1992 Corvette: Service Bulletin: Hood Latch Striker Bolt

Subject: HOOD LATCH STRIKER BOLT (USE PAST MODEL SERVICE PARTS)

Model and Year: 1992 Corvettes, Prior to VIN Breakpoint N5100919

Bulletin Number: 92-43-10 - (11/07/1991)

VIEW A

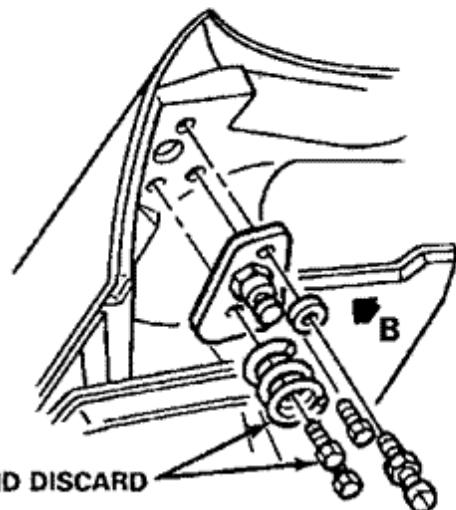
1. Raise hood to full open position. 2. Remove pop up spring and attaching bolt from bracket and discard (see View A). 3. Install new attaching bolt in position, tighten and torque to 27 N.m (20 lbs. ft.). 4. Loosen the locking nut on the striker latch bolt, remove bolt and nut from hood bracket, disassemble nut from bolt and save the nut for use on the new striker bolt. **DISCARD THE ORIGINAL STRIKER BOLT.** 5. Preassemble the new bolt, retainer, spring and original lock nut (see View B).

VIEW B — PRODUCTION

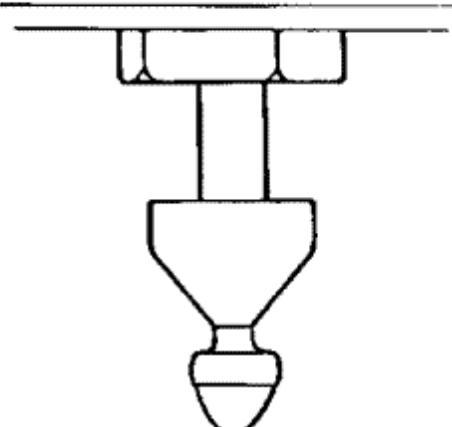
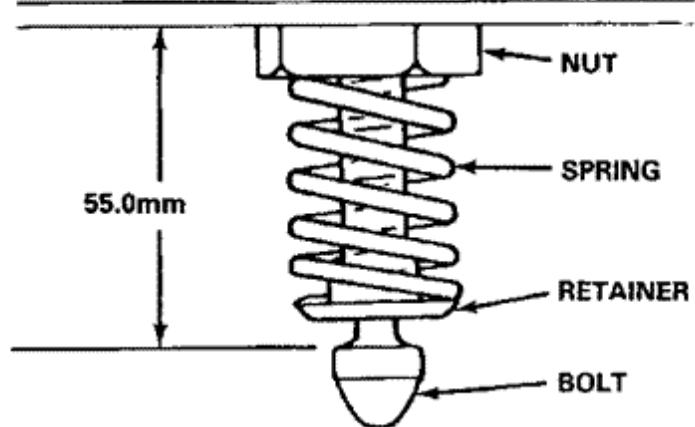
NOTE: The nut has a cavity on one side to act as spring seat.

6. Install the new striker bolt assembly to the bracket on hood, set initial

height as indicated on the illustration and tighten the locking nut. 7. Remove the outer attaching bolt for the spring seat (View C), loosen the inner attaching bolt and remove and discard the spring seat and outer attaching bolt. 8. Tighten the inner attaching bolt and torque to 25 N.m (18 lbs. ft.), see View C, inside View. 9. Carefully lower hood, check for latching and flushness conditions and adjust as required.
